Quality Assurance Audit Report
Technical Systems Audit
Sinclair Wyoming Refining Company
Ambient Air Monitoring Program
May 22-29, 2019

U.S. Environmental Protection Agency
Region 8

Executive Summary

Figure 6. North East Hourly Ambient SO₂ and Zero Check Values

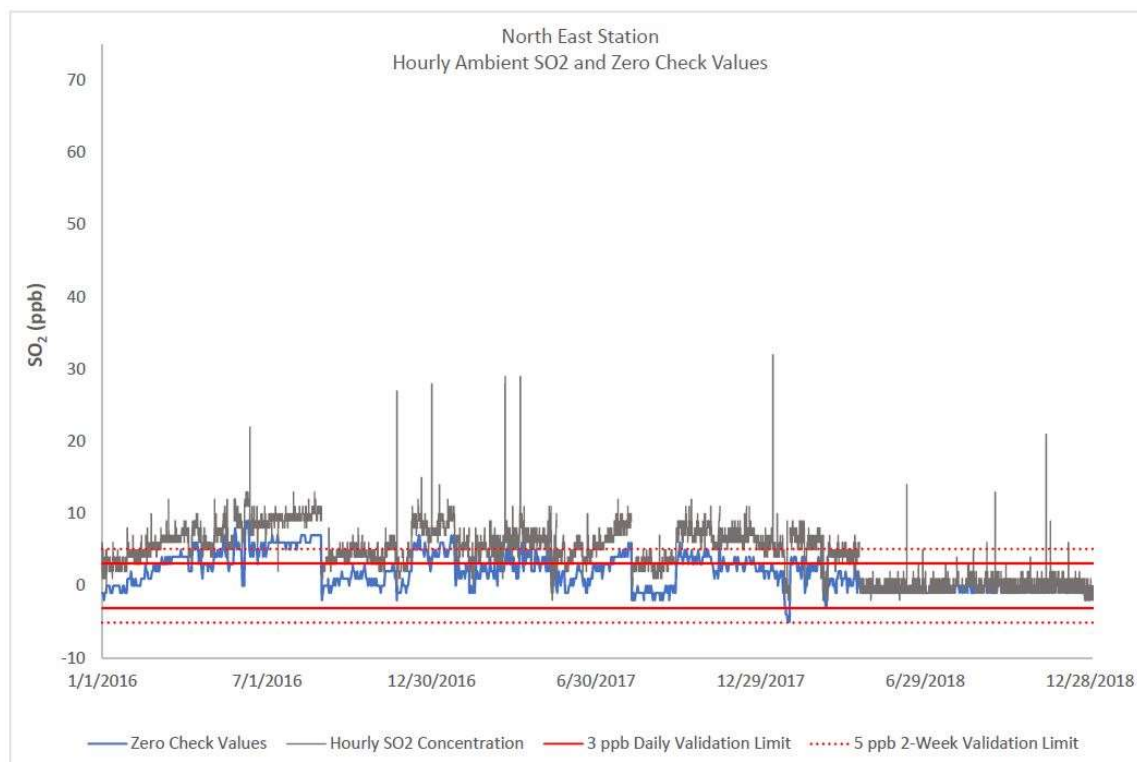
Review of the 2016, 2017, and 2018 quarterly data reports revealed periods of data where the zero checks exceeded the QMP/QAPP and validation template acceptance criteria (Figures 6, 7, 8, and 9). The data associated with these bad QC checks were not invalidated or otherwise flagged. The majority of these acceptance limit exceedances were at the North East site, but exceedances were noted at the In-Town Station as well.

As shown in Figure 6, the North East Station had numerous occasions where the SO₂ zero-check values fell well above 3.1 ppb. The analyzer was allowed to operate like this for weeks (and sometimes months) at a time. A number of checks even fall above 5.1 ppb, which would be the limit for biweekly checks. The effect on the data is obvious from the plot. The hourly SO₂ concentrations have a direct and proportional relationship with the zero-check results. The NO_x analyzer also had exceedances of the data validation limits (Figure 7), although the excursions occurred over shorter periods than for the SO₂.

Recommendation: The QMP/QAPP needs to spell out how the team keeps analyzers in control. This typically consists of identifying and implementing an action limit that is less than the acceptance criteria. The QMP/QAPP should specify what actions are taken to correct the issue when action limits are reached and how the data will be validated or invalidated when acceptance criteria are exceeded.

Additionally, due to the lack of evidence to demonstrate all the SO₂ data at the North East Station are of acceptable quality, all data with failing zero-checks should be invalidated in AQS unless there is compelling evidence that the data are of acceptable quality. Data invalidation should also be performed for the other stations and analyzers affected by this finding.

Figure 16. Where the sample and calibration lines enter the conduit on the roof of the In-Town Station.

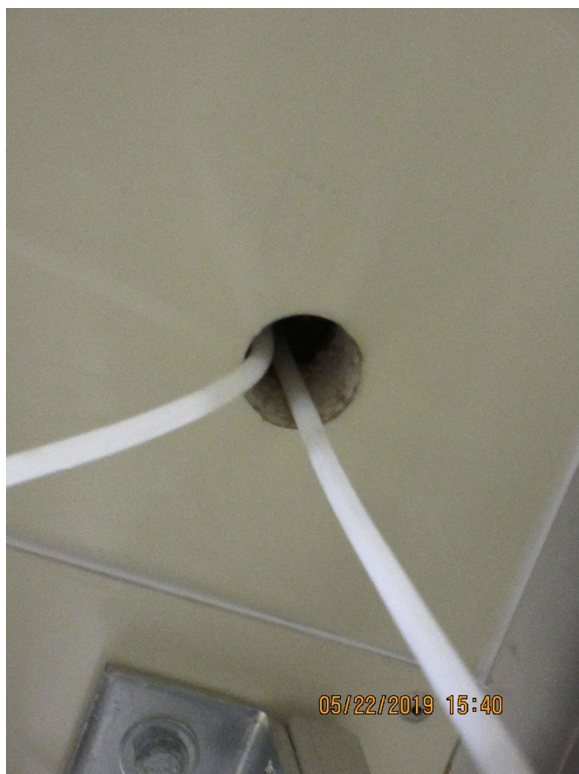
The In-Town and North Est shelters have a piece of conduit that attaches to the roof and the inlet cover. The sample line runs through the conduit (Figure 15). The auditor could not identify any plugs in the conduit (Figure 16). The concern is that if the shelters have positive pressure (from

equipment venting into the shelter or from the HVAC system) the air will be forced up through the conduit and sampled by the inlets.

Recommendation: All conduit carrying sampling lines should be plugged to prevent any shelter air from being forced up the conduit and inadvertently sampled.
